UN#12-067

Subject: UniStar Nuclear Energy, NRC Docket No. 52-016
Correction of Final Safety Analysis Report (FSAR) Figure 8.3-1
in Calvert Cliffs Nuclear Power Plant, Unit 3, Combined
License Application (COLA) Revision 8

**Correction of Final Safety Analysis Report (FSAR) Figure 8.3-1,
COLA Revision 8, Calvert Cliffs Nuclear Power Plant, Unit 3**

Figure 8.3-1 — {CCNPP Unit 3 Emergency Power Supply System Single Line Drawing}
(Page 1 of 3)

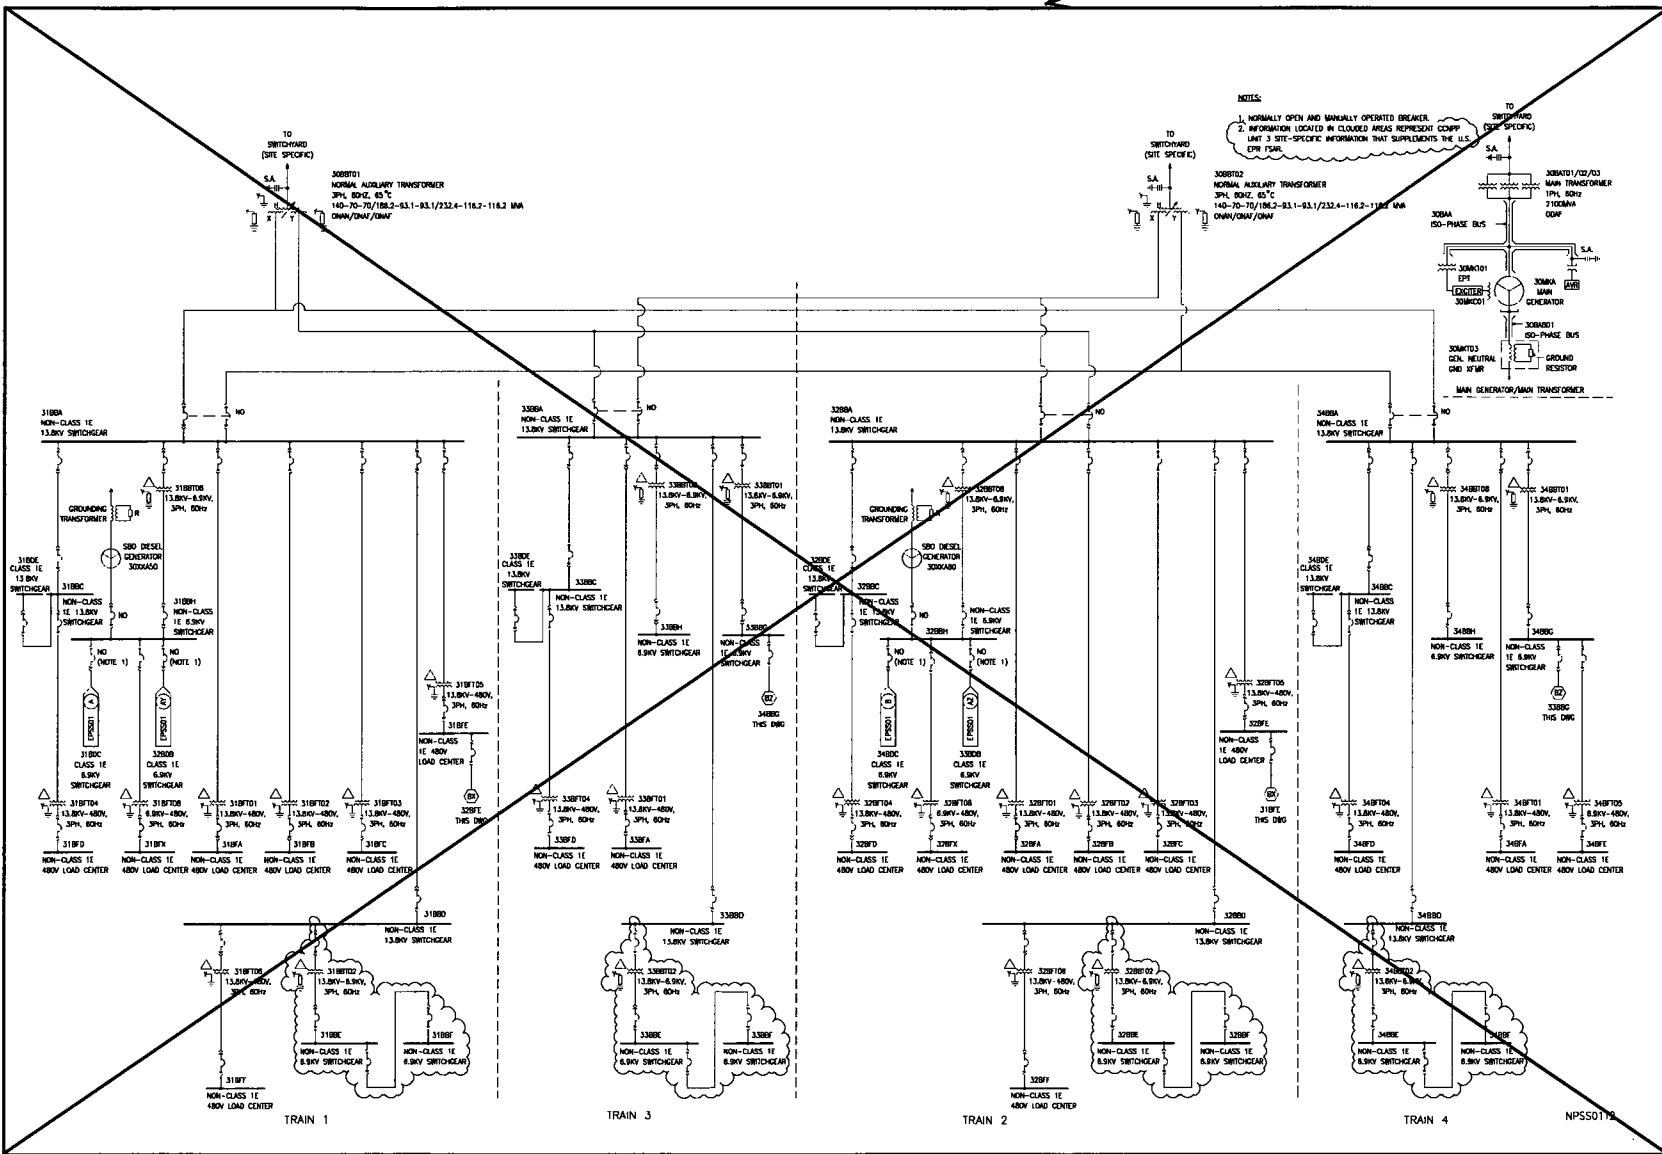
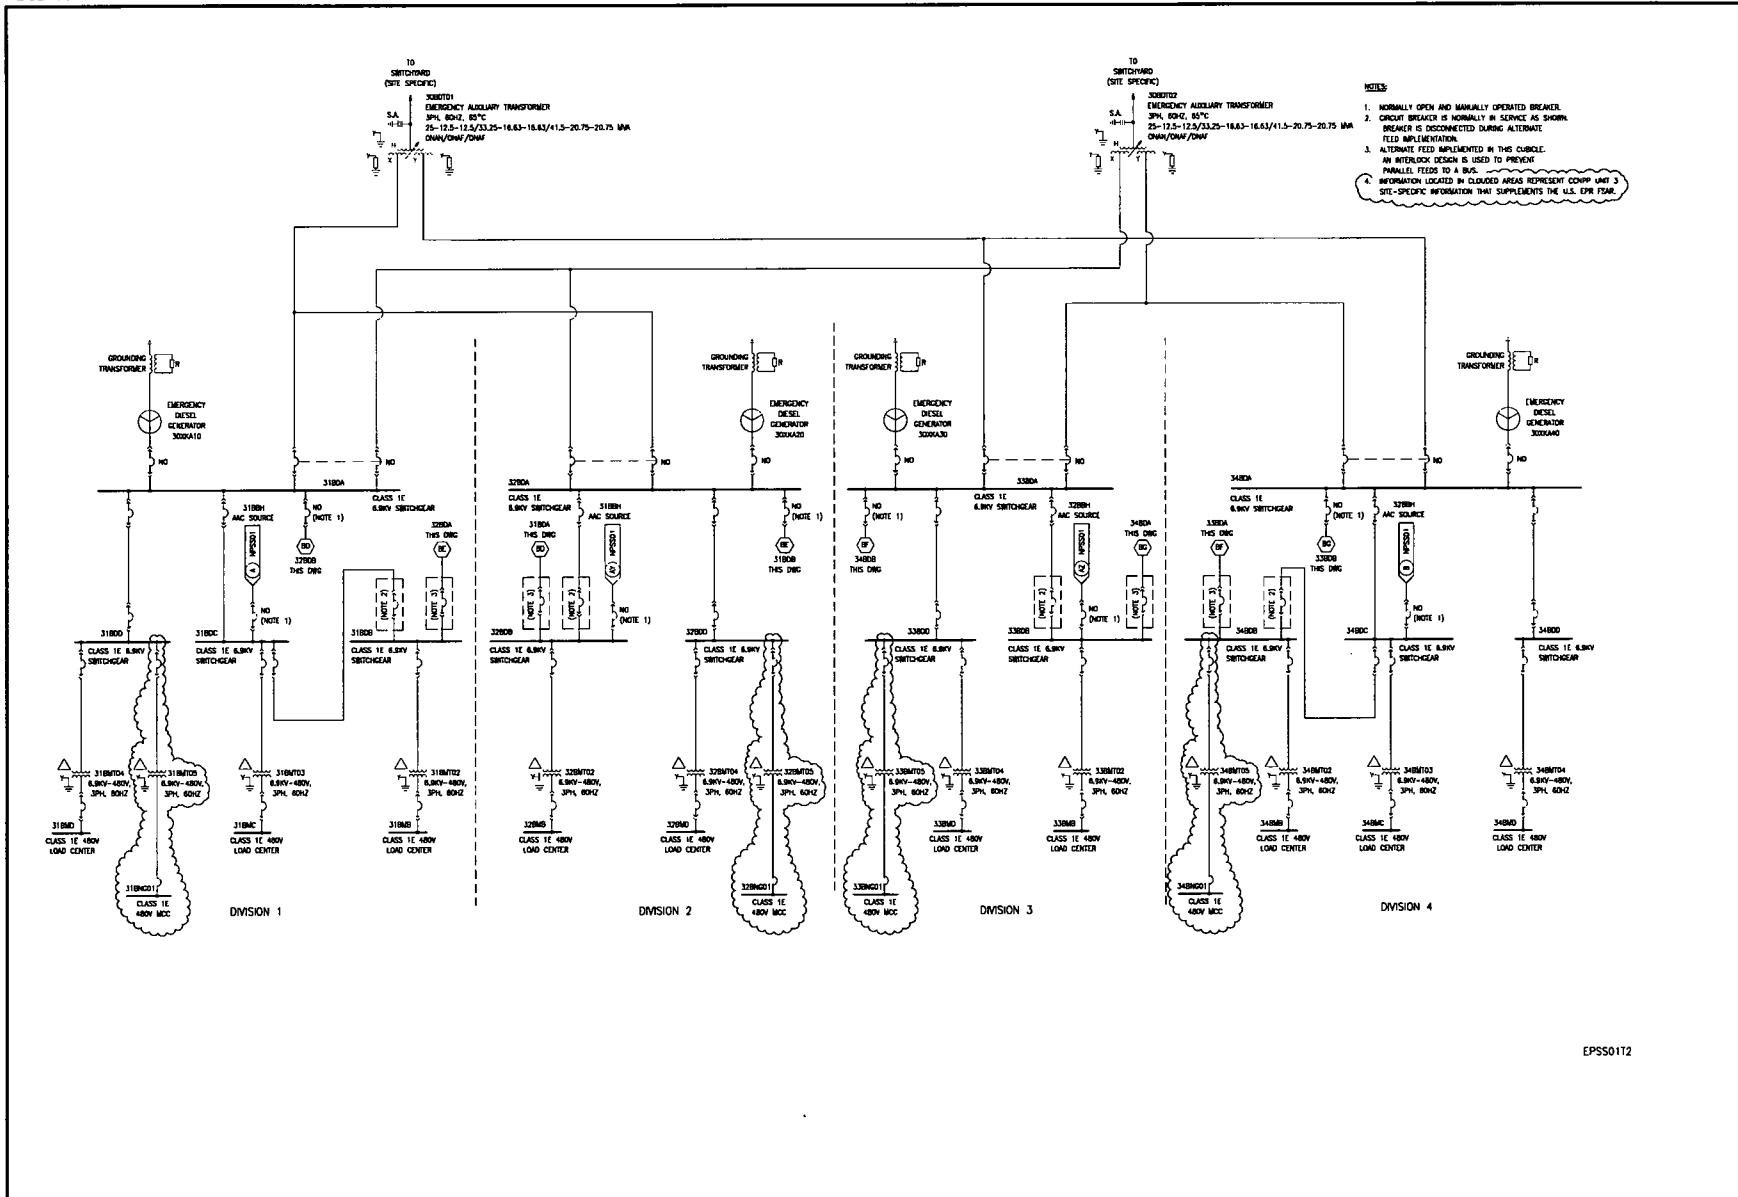
The purpose of this letter is to provide a correction to Final Safety Analysis Report (FSAR) Figure 8.3-1 as presented in Calvert Cliffs Nuclear Power Plant (CCNPP), Unit 3, Combined License Application (COLA) Revision 8 (Reference 2). In a call with the CCNPP NRC Project Manager, UniStar Nuclear Energy (UNE) was questioned why FSAR Figure 8.3-1 was revised in COLA Revision 8. The revised Figure 8.3-1 was incorrect.

Initial investigation into this condition revealed that COLA Revision 8 changes were required to subsequent FSAR Figure 8.3-2 (Pages 1, 3, and 5 of 5). However, in COLA processing, FSAR Figure 8.3-1 (Pages 1 through 3) were also inadvertently replaced with the duplicate FSAR

Figure 8.3-2 pages (Pages 1, 3, and 5 of 5). A condition report regarding the incorrect FSAR Figure 8.3-1 revision in COLA Revision 8 has been entered into the UNE corrective action program for disposition.

FSAR Figure 8.3-1 should not have been revised in COLA Revision 8. FSAR Figure 8.3-1, as shown in COLA Revision 7 (Reference 1), remains correct. The enclosure to this letter provides a markup of the correction which is being made to FSAR Figure 8.3-1 to restore the correct figure. A Licensing Basis Document Change Request has been initiated to incorporate these changes into a future revision of the COLA.

Insert 1

Insert 1
